From: PUBCOMMENT-OCC
Sent: Wednesday, April 28, 2021 9:48 AM
To: PUBCOMMENT-OCC2; PUBCOMMENT-OPIC; PUBCOMMENT-ELD; PUBCOMMENT-WPD
Subject: FW: Public comment on Permit Number 2406

REGULATED ENTY NAME PEACH CREEK ENVIRONMENTAL PARK

PERMIT NUMBER: 2406

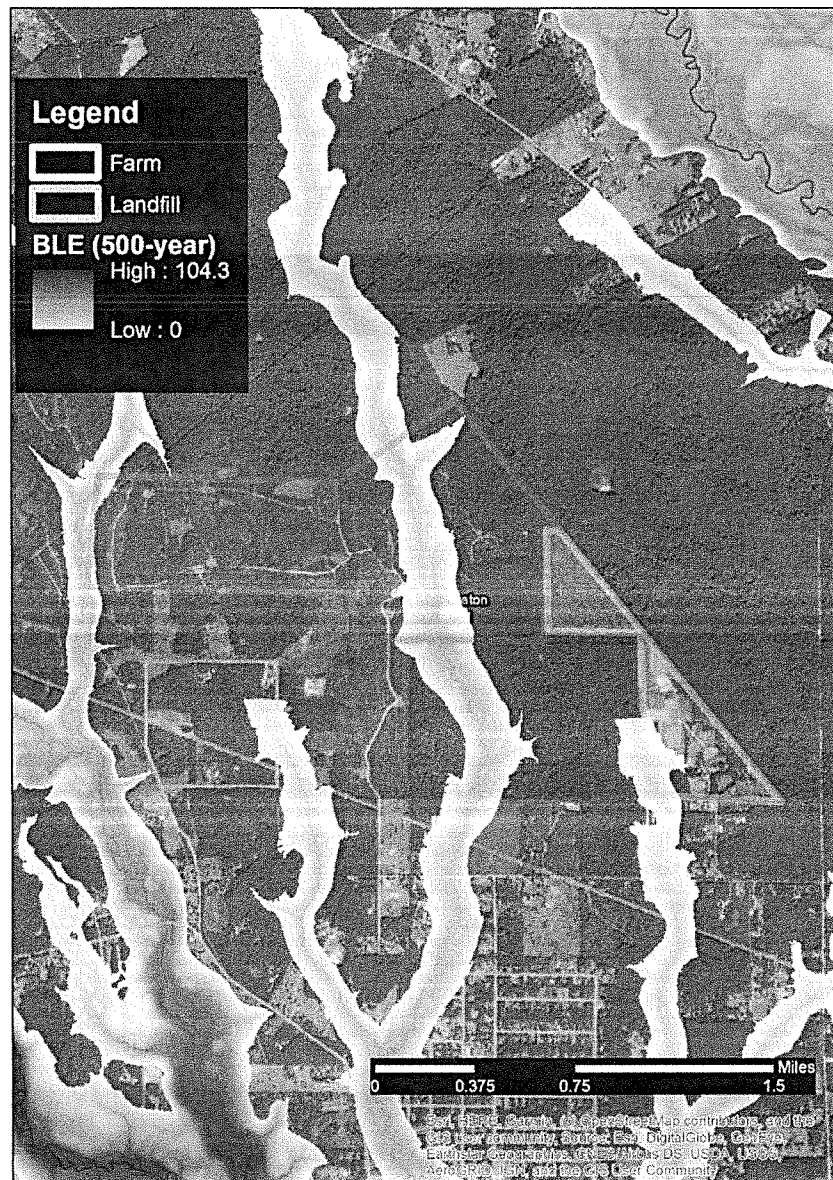
Comparison of effective FEMA floodplains and more recent BLE 100-year floodplains. It is clear the newer data show generally broader floodplains, and even some locations vulnerable to flood flows that are not identified by FEMA flood hazard maps at all.

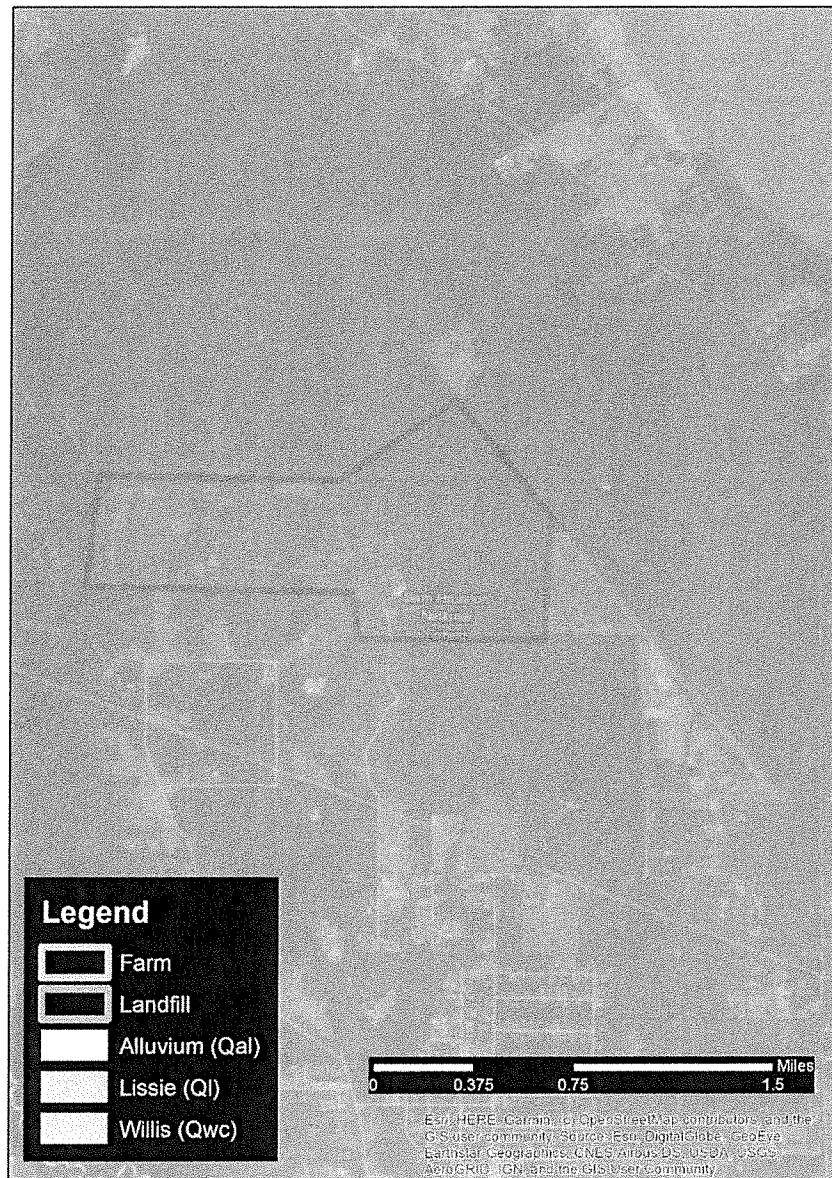
Flood risk of the farm and proposed landfill site as determined by First Street Foundation, via Flood Factor. This is the most robust modeling approach used to date and was released in 2020. The flow pathways that appeared truncated on the maps of floodplains more realistically reflect the direction of water flow. Once again, more high-quality data reveals greater flood risk than previously indicated.

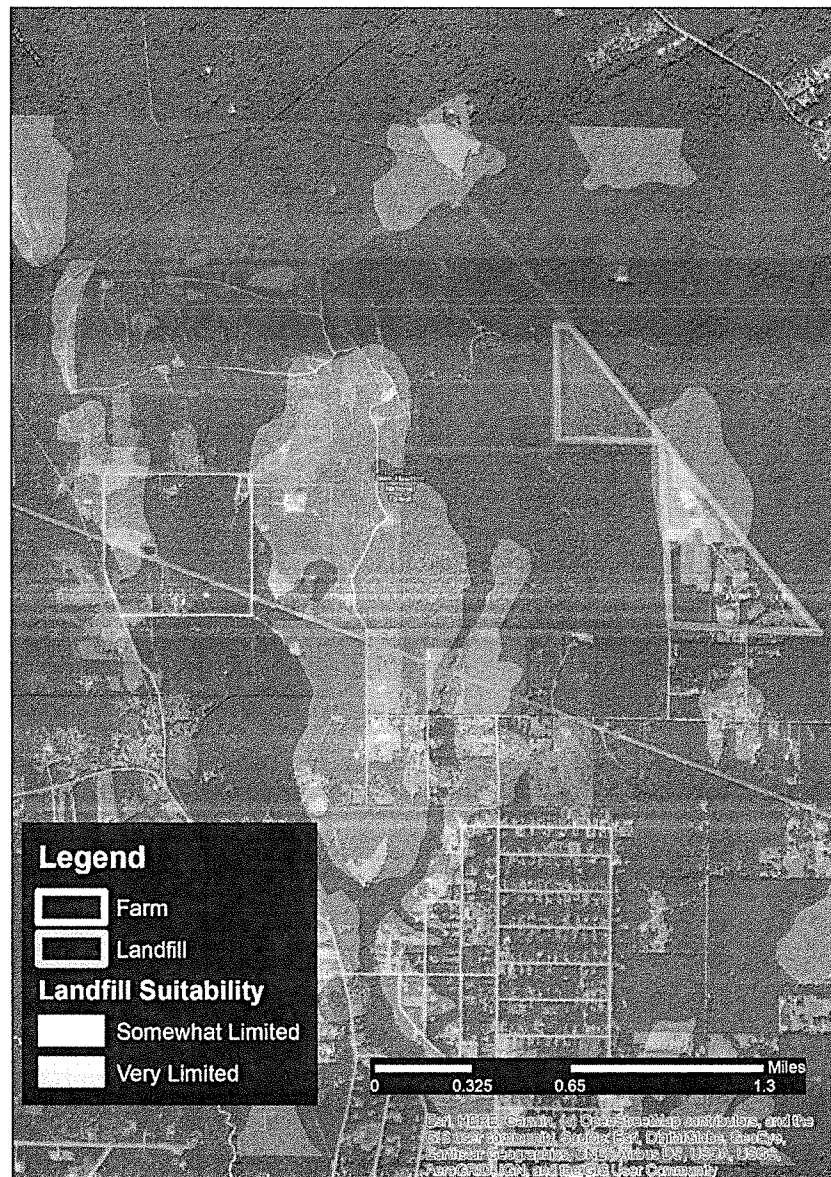
Location of different geological formations in relation to the farm and proposed landfill site. Different geological layers usually indicate different subsurface materials and differences in physical processes. Data from Texas Natural Resources Information System and University of Texas Bureau of Economic Geology via U.S. Geological Survey Pocket Texas Geology.

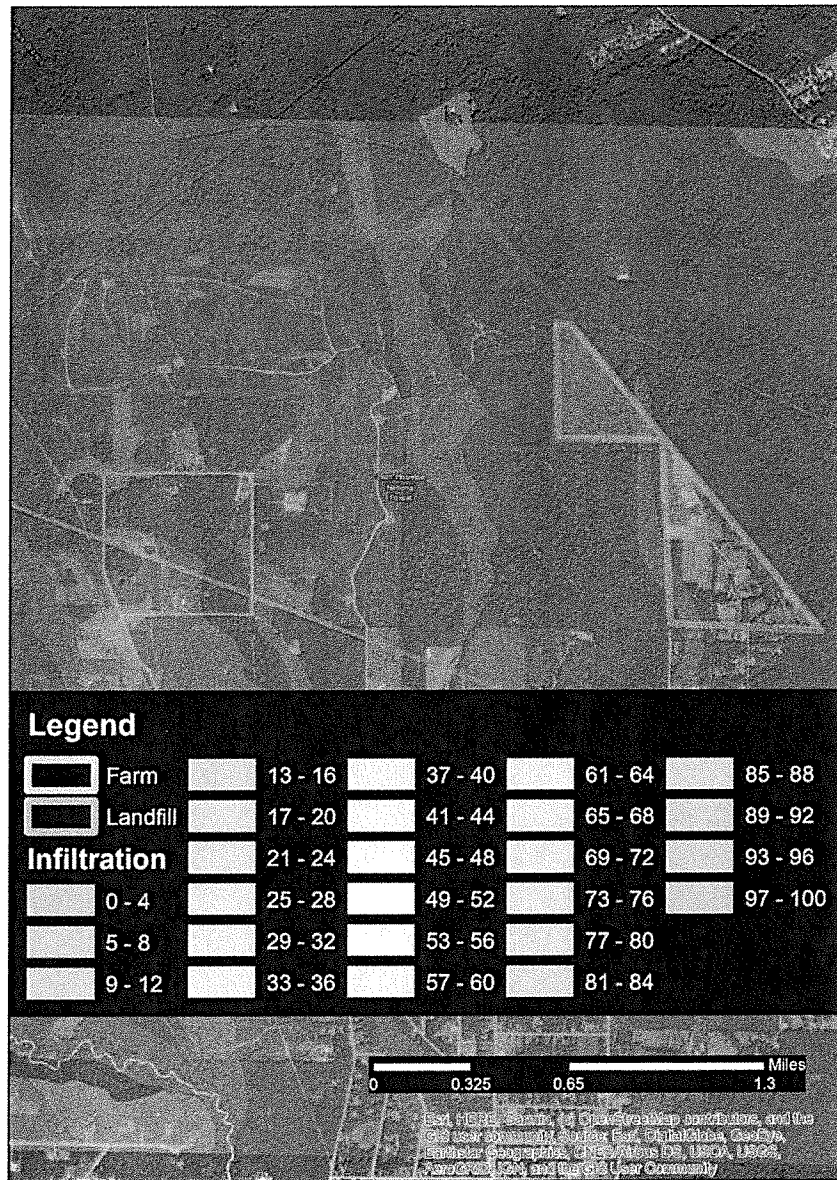
Assessed suitability of soils for landfill use. Data from USDA-Natural Resources Conservation Service via Web Soil Survey Suitabilities and Limitations Ratings for "Sanitary Landfill (Area)." Most of the area is very limited for use as a sanitary landfill. This can be due to several soil variables.
